# Access Compliance Report

## Public Rights-of-Way

### (Curb Ramps)

Intersection ID: 43361	Main Street: PROSPERITY COMMONS DR	Cross Street: RIDGEVIEW COMMONS DR	Location: SW
ADA ID: A60B27EB9021	Ramp Type: BlendTrans1	Initial Pass/Fail: Fail	Overall Compliance: No
Codes/Mitigation Info/Possible Solution		Field Measurements/Component Compliance	
Severity Score: 12.5

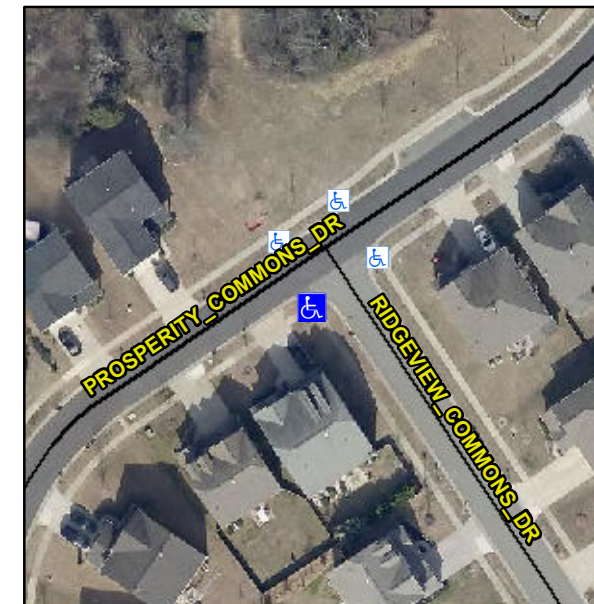
**Not Found, R304.5.3**

Compliance	Description	Data	Compliance	Description	Data
N/A	Ramp Length (in)	71.5	Yes	BlendTrans Slope (%)	4.3
Yes	Ramp Width (in)	48.0	No	BlendTrans XSlope (%)	5.8
N/A	Flare Type LT	N/A	N/A	Flare Type RT	N/A
N/A	Flare Slope LT (%)	N/A	N/A	Flare Slope RT (%)	N/A
N/A	Flare Traversable LT?	N/A	N/A	Flare Traversable RT?	N/A
N/A	Landing Length (in)	N/A	N/A	DWS Provided?	N/A
N/A	Landing Width (in)	N/A	N/A	DWS Contrast?	N/A
N/A	Landing Slope (%)	N/A	N/A	DWS Length (in)	N/A
N/A	Landing X Slope (%)	N/A	N/A	DWS Full Width?	N/A
N/A	Landing Curb? (Y/N)	N/A	N/A	DWS Offset (in)	N/A
N/A	Shared Landing?	N/A			
N/A	Gutter Ponding?	N/A	N/A	Gutter Slope (%)	N/A
N/A	Gutter Lip Ht (in)	N/A	N/A	Gutter X Slope (%)	N/A
N/A	Painted X Walk1?	No	N/A	Painted X Walk2?	No
	X Walk 1 Direction	To E		X Walk 2 Direction	To N
	X Walk 1 Width (in)	N/A		X Walk 2 Width (in)	N/A
	X Walk 1 Slope (%)	3.9		X Walk 2 Slope (%)	4.0
	X Walk 1 X Slope (%)	0.1		X Walk 2 X Slope (%)	2.9

N/A	Ramp inside XWalk1?	N/A	N/A	Ramp inside XWalk2?	N/A
	Road Slope (%)	2.8		Clear Space?	N/A
	Road X Slope (%)	4.5	N/A	Clear Space to XWalk (in)	N/A
N/A	Any Obstructions?	N/A	N/A	Storm Grate/Utility Hazard?	N/A
	Obstruction Type			Storm Grate/Utility Type	
		N/A			N/A
			Yes	Surface Condition? (G/P)	Good
			No	Curb Slope (%)	14.2

**Remove & Replace Curb Ramp With Two New Directional Ramps or Equivalent.**
